AQUALAND

ACCESS DESIGN REVIEW – DEVELOPMENT APPLICATION (DA)

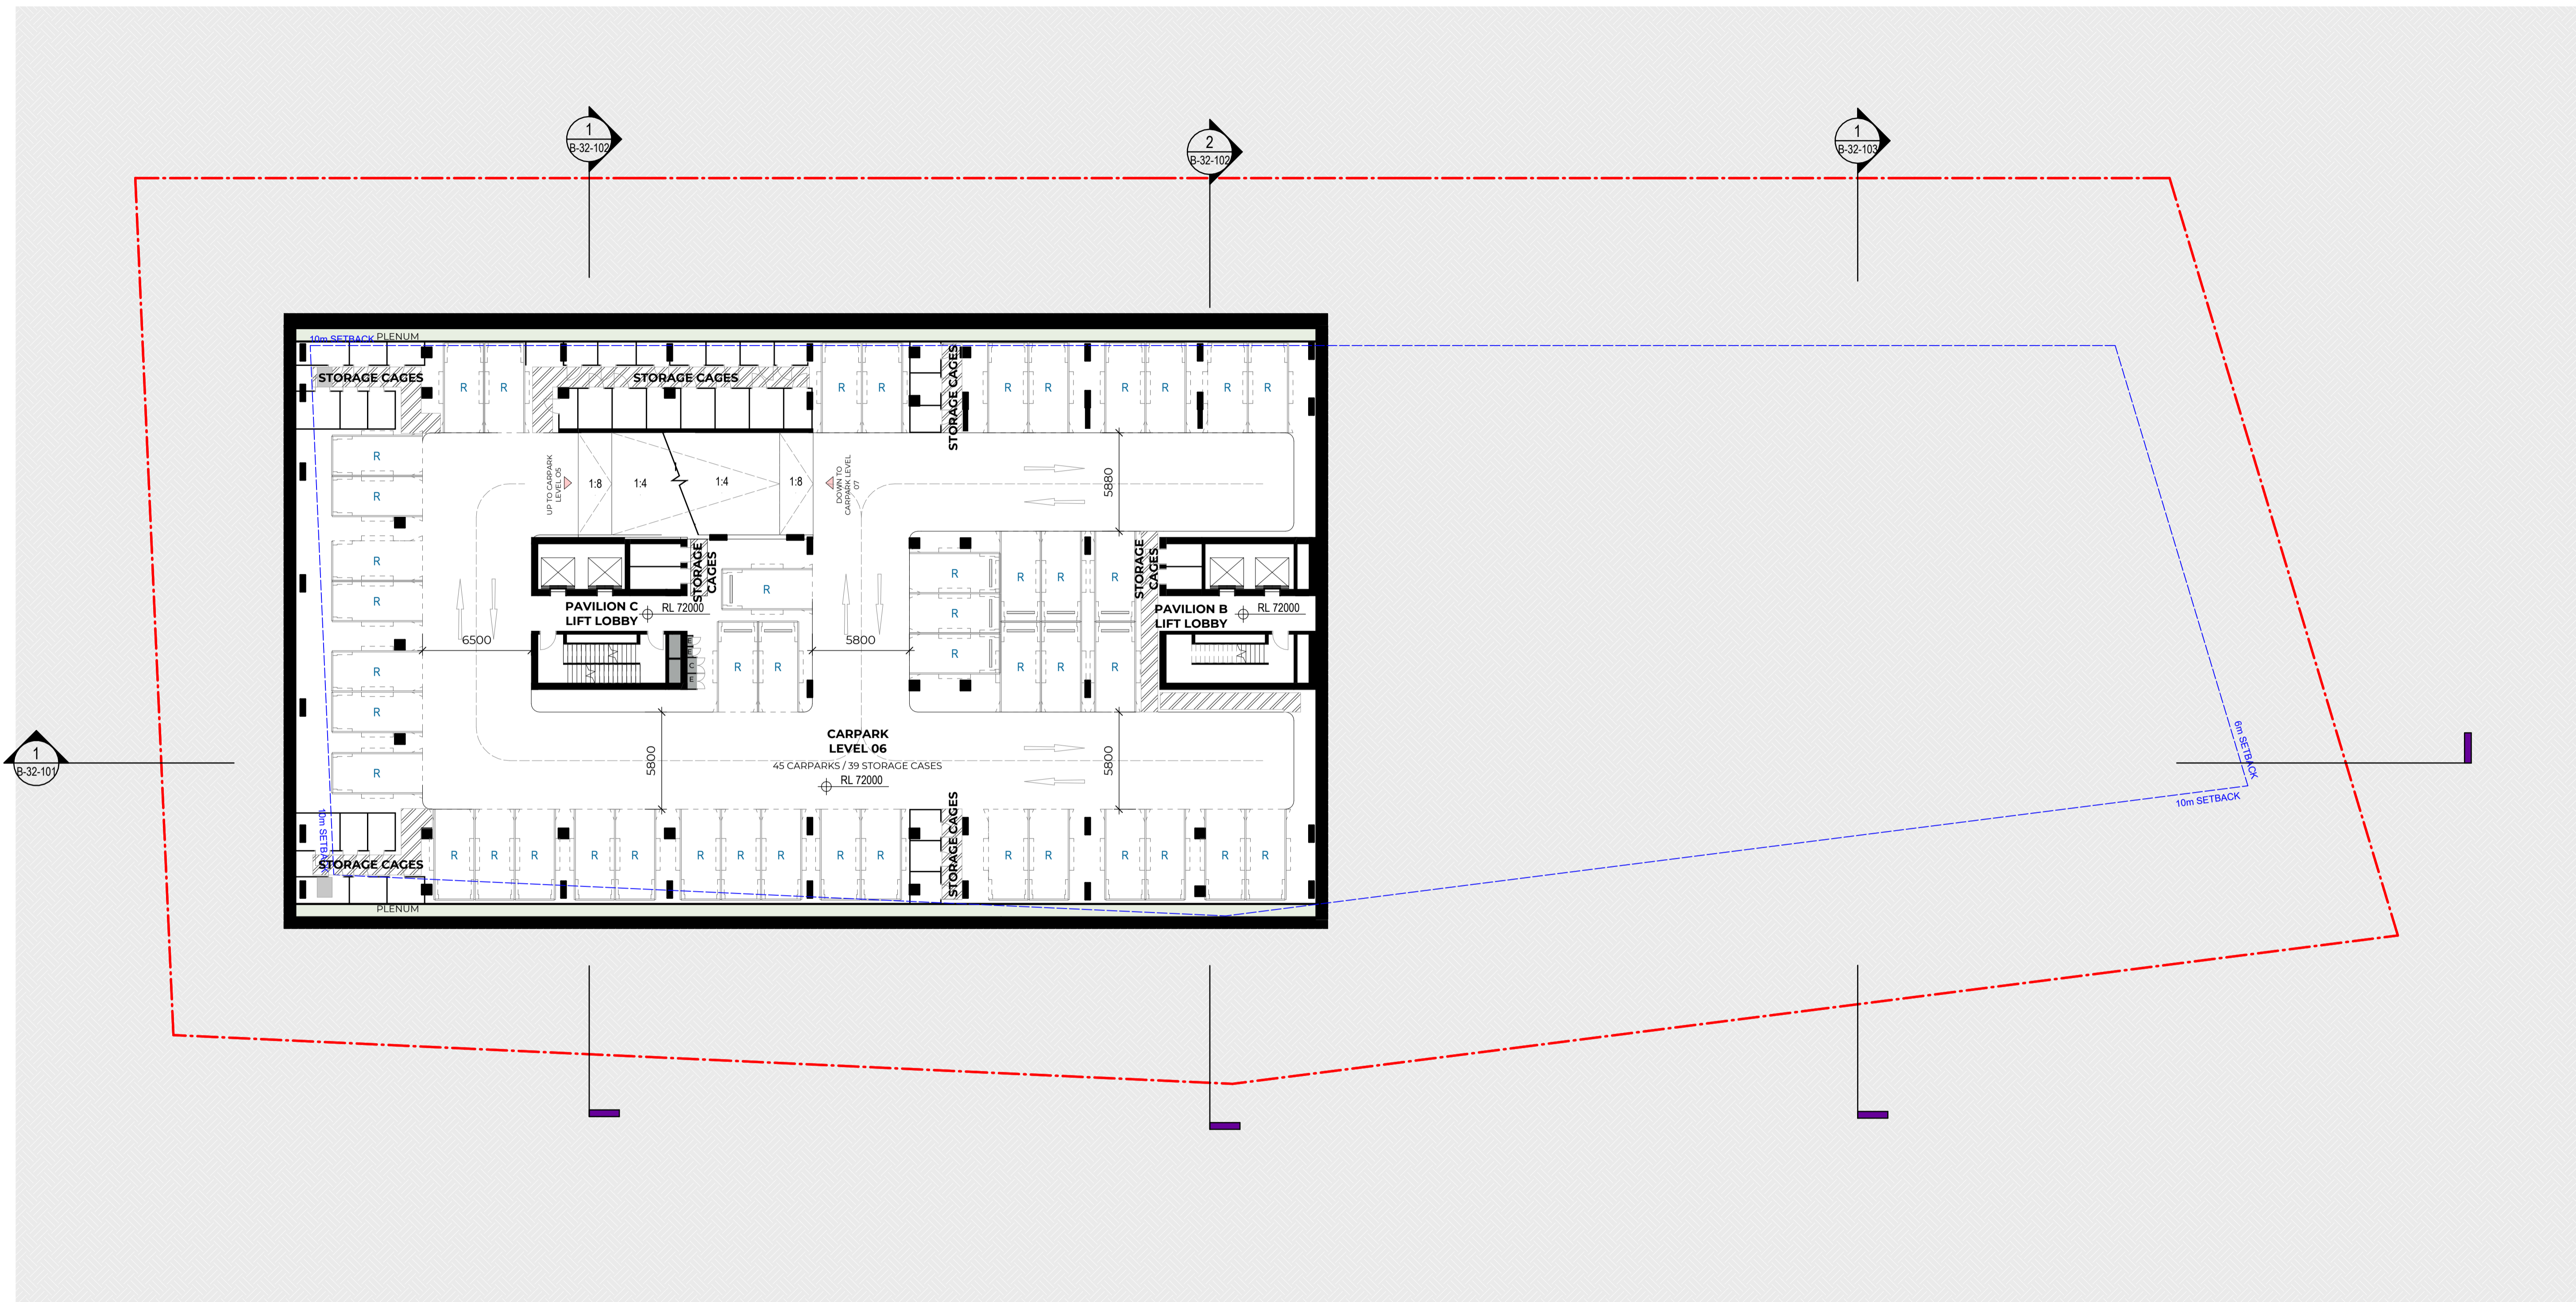
Orange comments relate to questions, clarifications and considerations moving forward
 Red comments relate to elements requiring adjustment

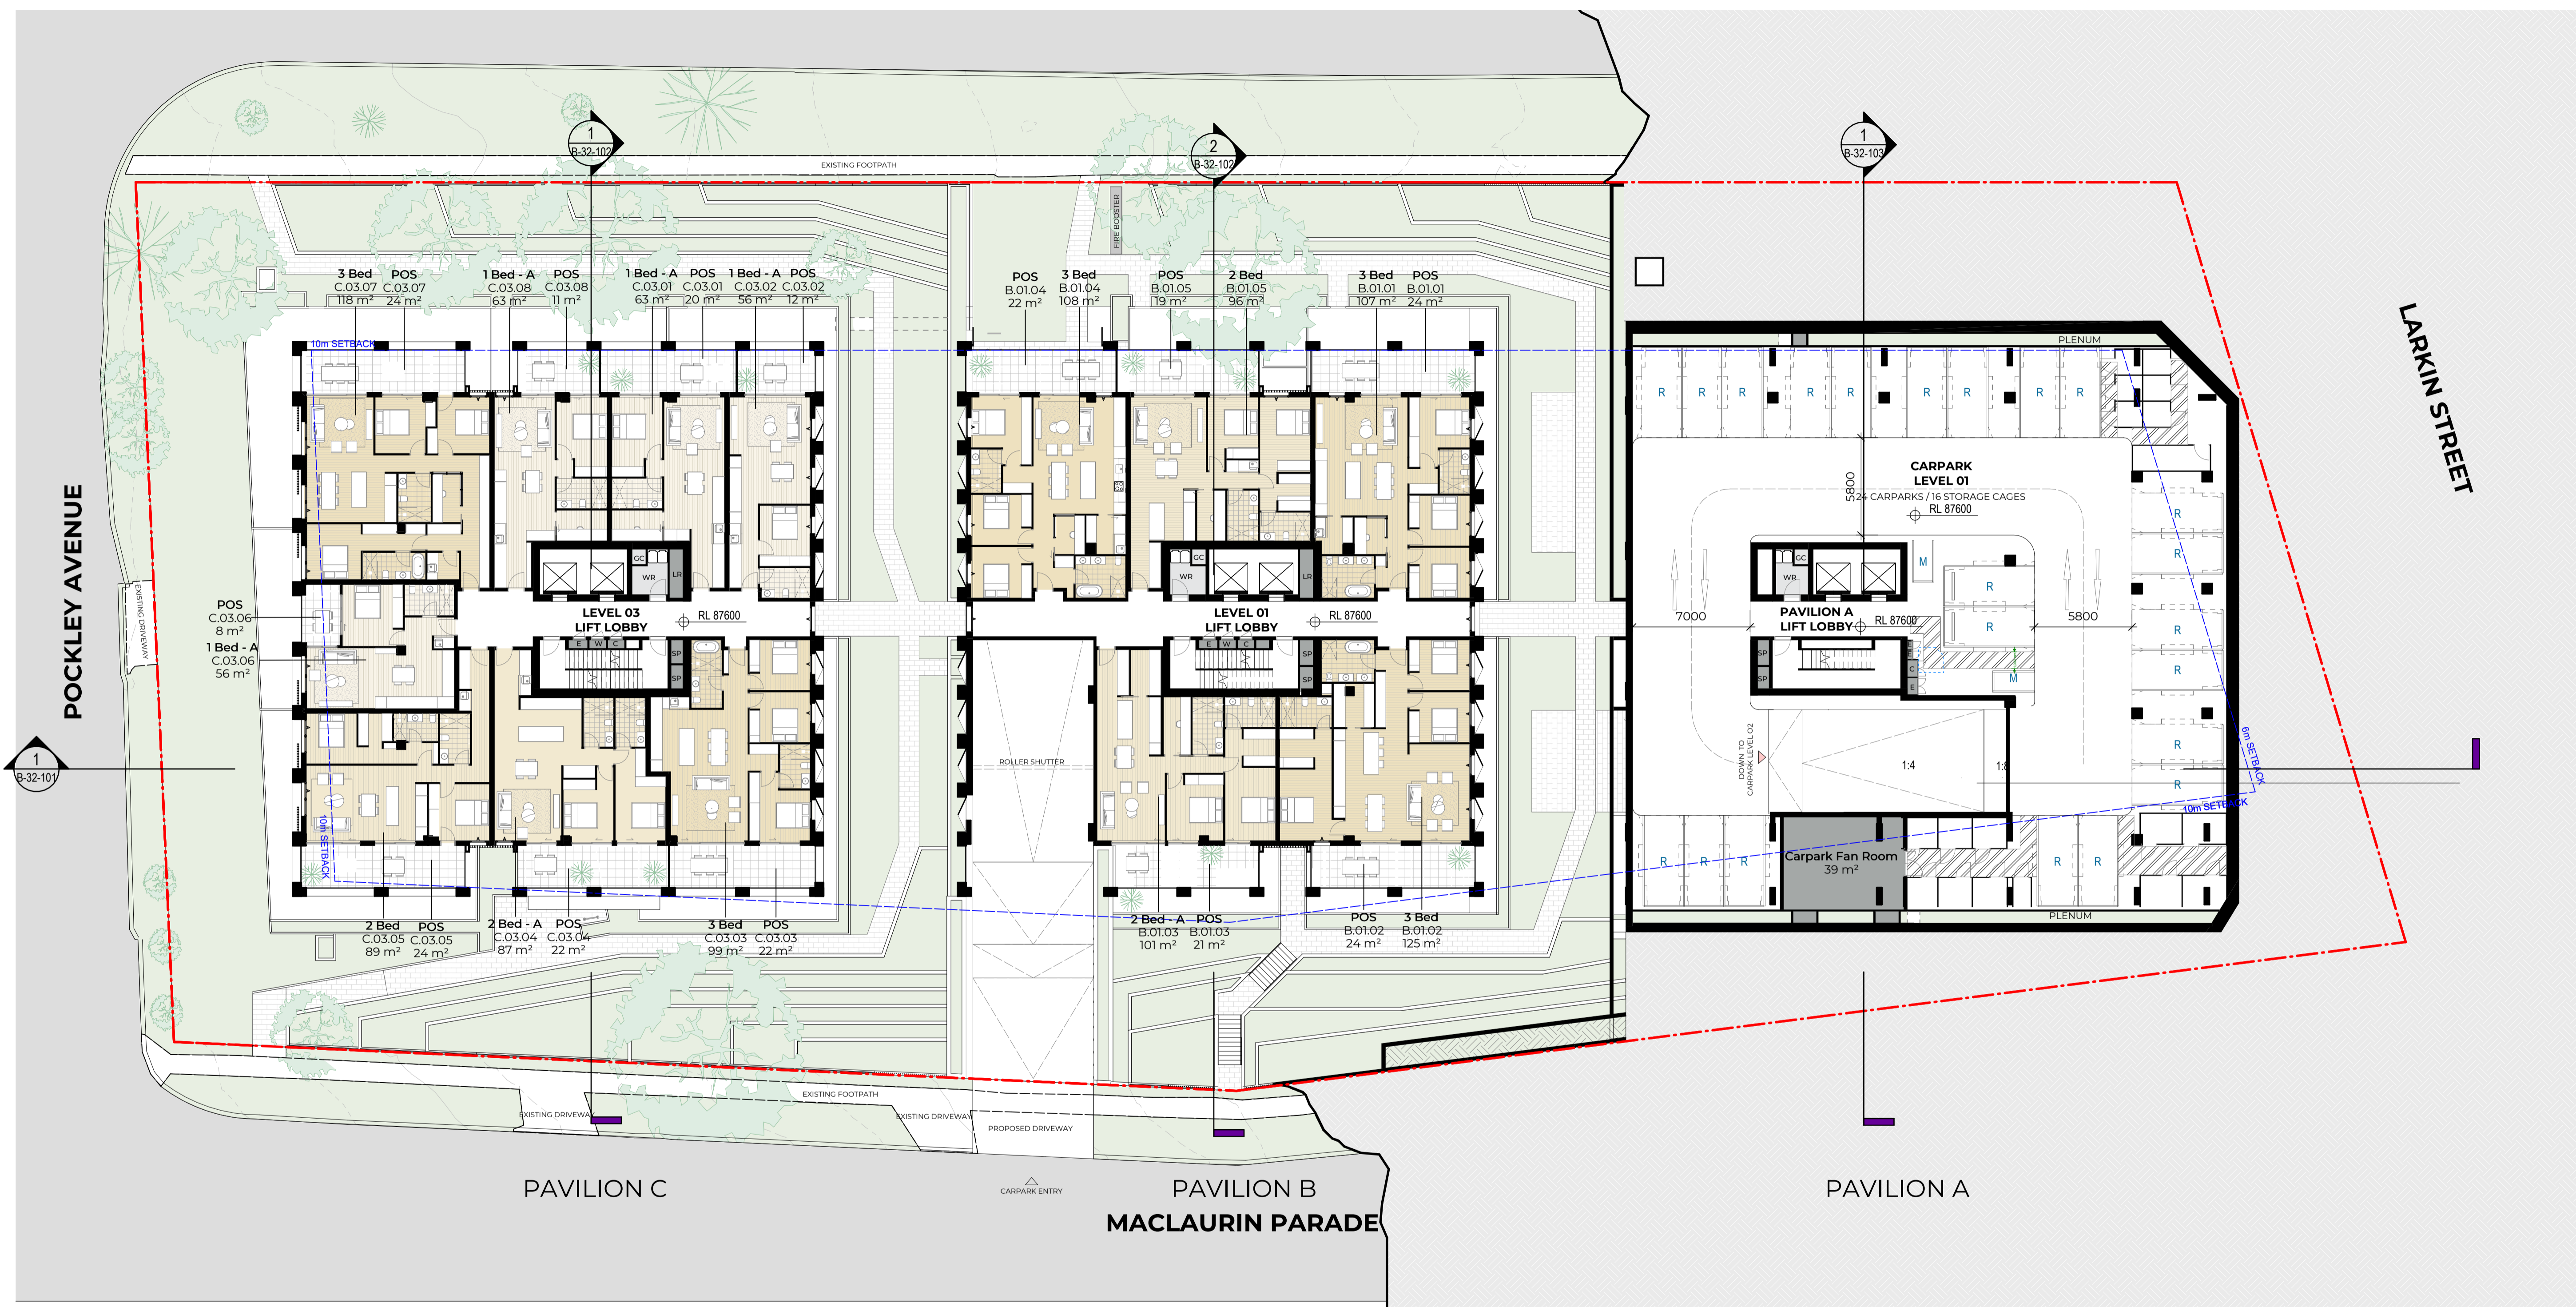
Orange comments relate to questions, clarifications and considerations moving forward
 Red comments relate to elements requiring adjustment

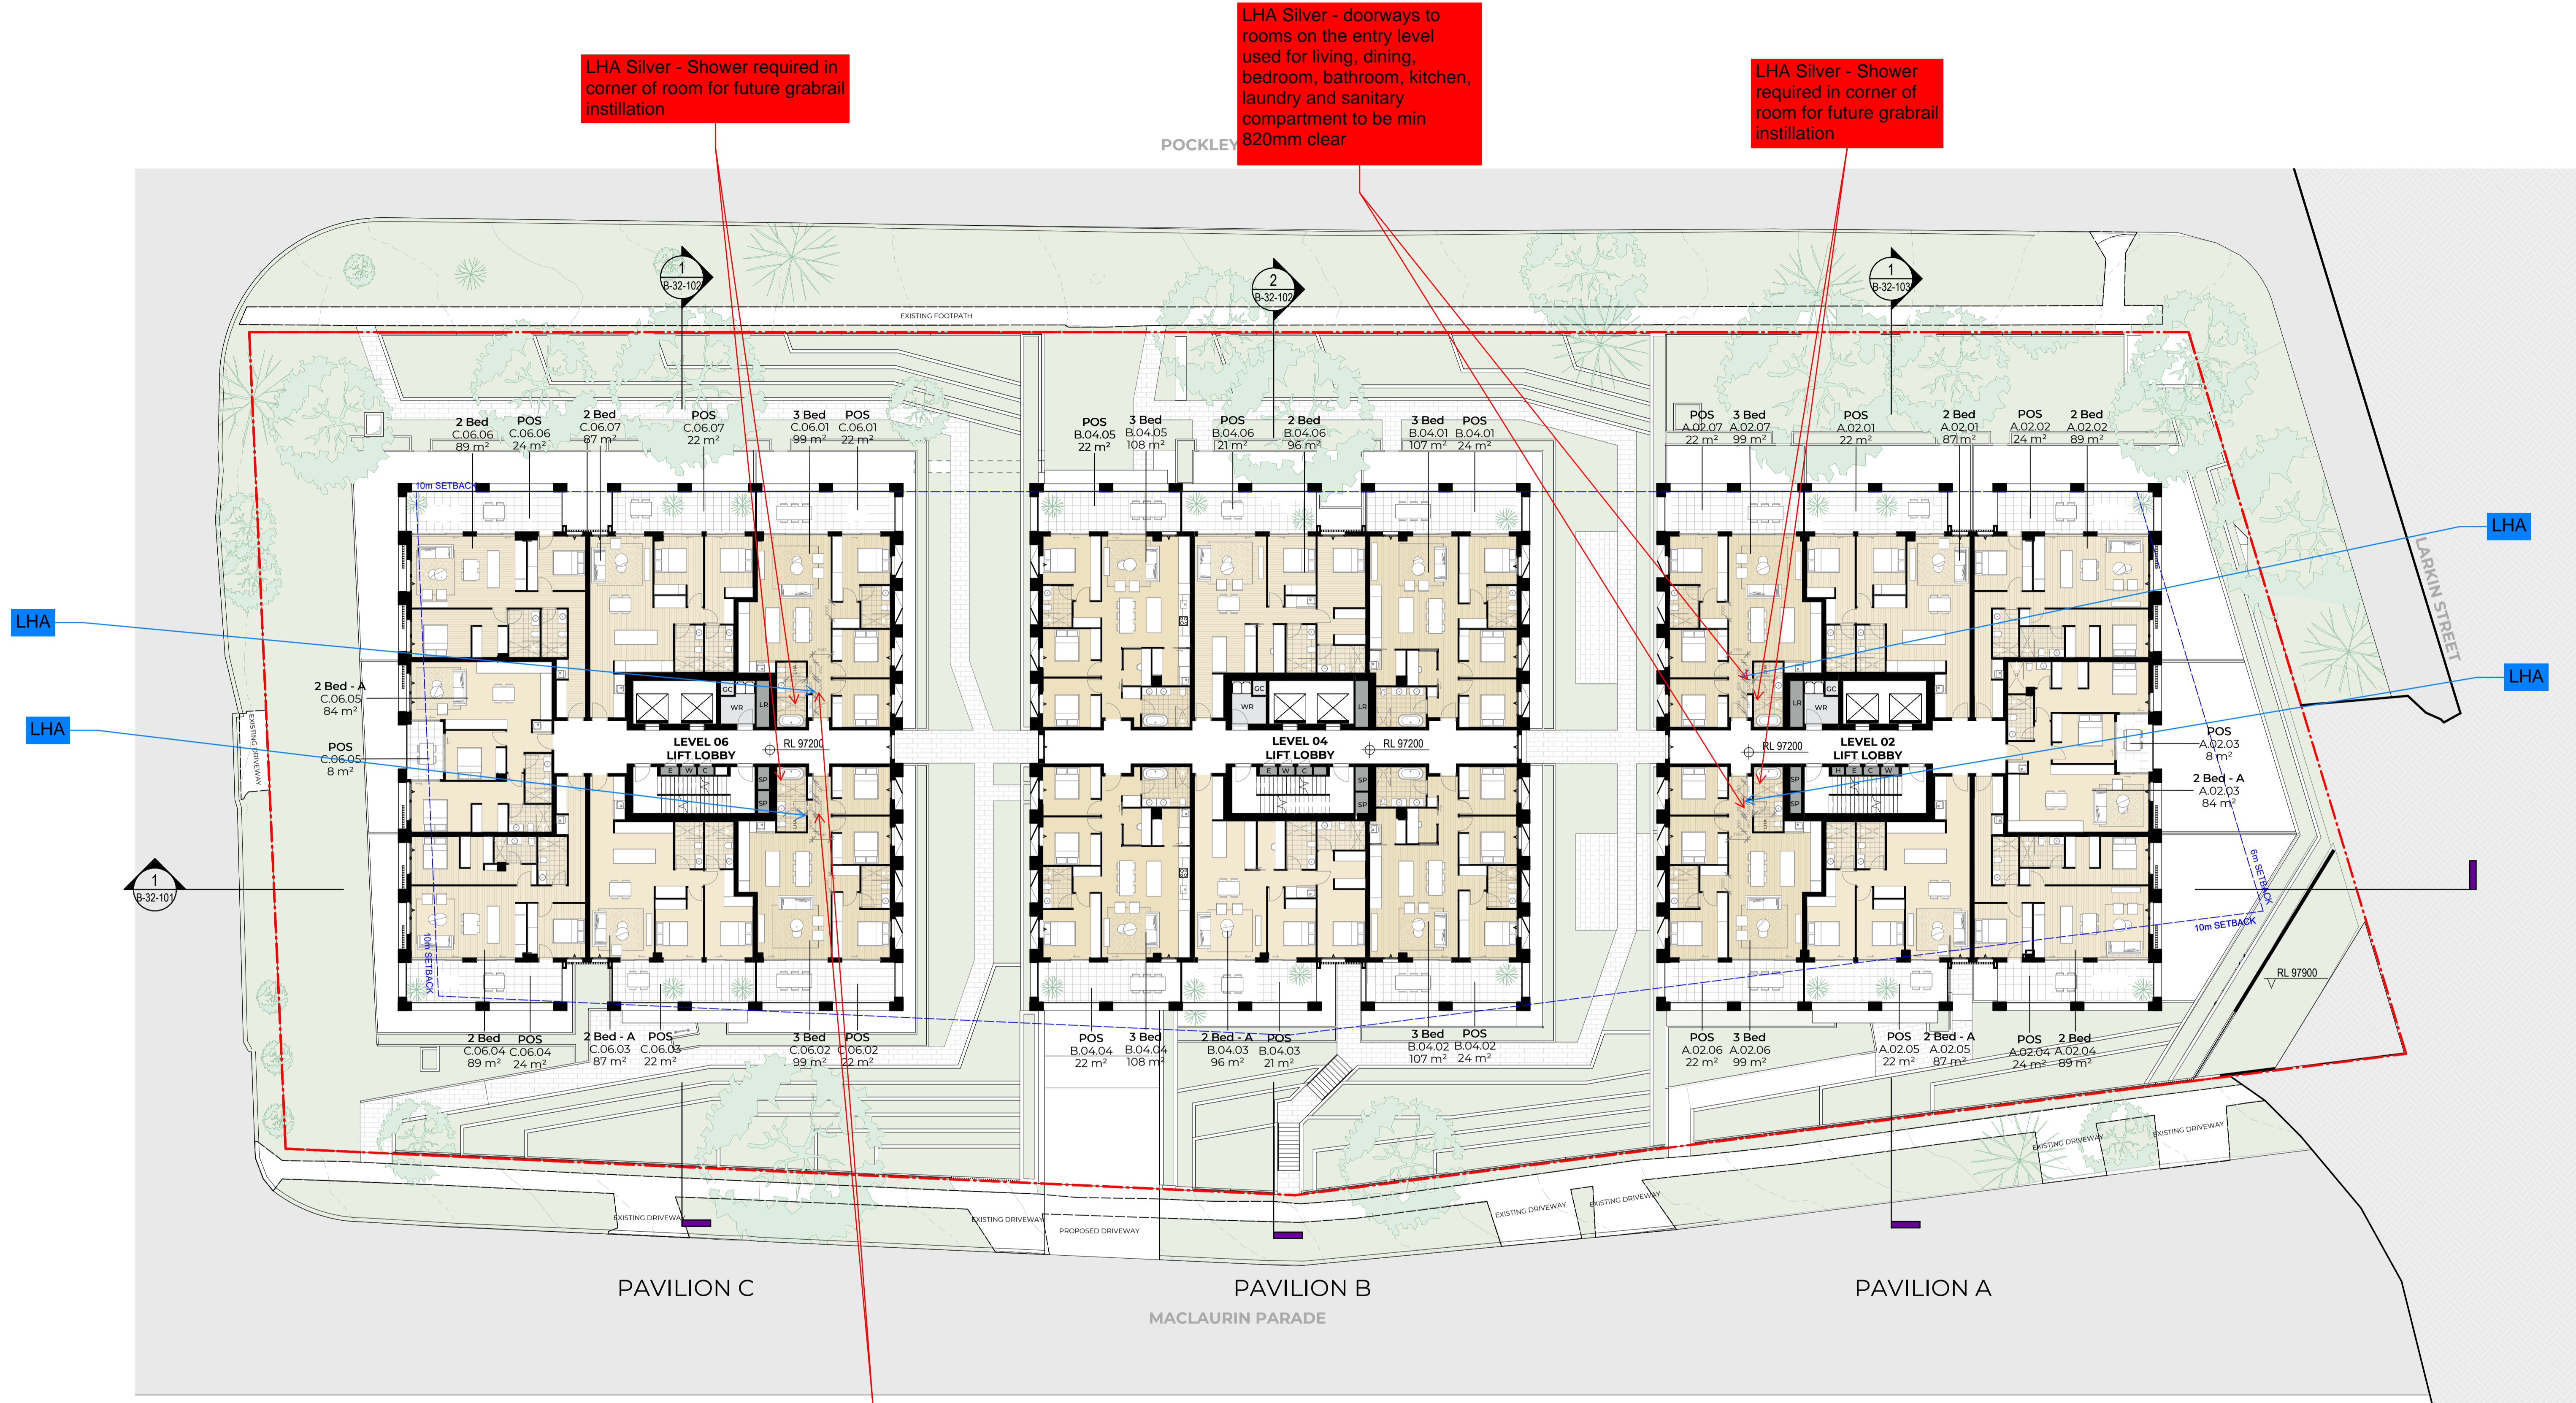
Orange comments relate to questions, clarifications and considerations moving forward
Red comments relate to elements requiring adjustment
